# UNITED STATES PATENT AND TRADEMARK OFFICE

APPLICATION NO.	FILING DATE	FIRST NAMED INVENTOR	ATTORNEY DOCKET NO.	CONFIRMATION NO.
10/524,155	01/30/2006	Steven D. Kloos	1330.013US1	2445
21186 7590 09/26/2008 SCHWEGMAN, LUNDBERG & WOESSNER, P.A. P.O. BOX 2938 MINNEAPOLIS, MN 55402				
EXAMINER				
MENON, KRISHNAN S				
ART UNIT		PAPER NUMBER		
1797				
MAIL DATE		DELIVERY MODE		
09/26/2008		PAPER

### **DETAILED ACTION**

FIG. 2B

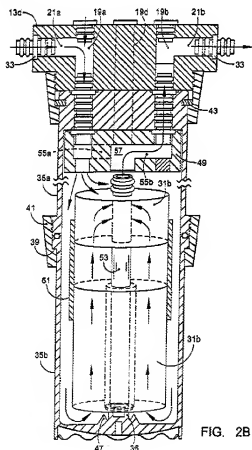
Beeman teaches (fig 2B below) a cartridge housing 35a attached to a socket on a manifold. This housing has a leg 35b with a portion 41 engaging the housing. The bottom portion of the leg (see the slot at 47) or the portion 41 can be used to tighten or loosen the housing portion. The leg including a generally triangular shape is not

patentable. The bottom of the leg in fig 2B can be made in triangular or any other shape.

There are plurality of housings, each housing has the same arrangement, and they have different filter elements. The collar 41 of the leg engages a threaded ridge on the housing. The leg also rotates in relations with the housing and the manifold, and can be used to tighten/loosen the housing to the manifold. The "wrench" in claim 87 does not carry any specific structure; the leg of the reference does engage the housing to the manifold.

Claims 38-40: The Examiner suggests replacing all occurrences of "one or more" with - - plurality of - - in these claims, and changing "cartridges" to - - cartridge housings - - to make them in condition for allowance. Other dependent claims may be made to depend from claim 38.
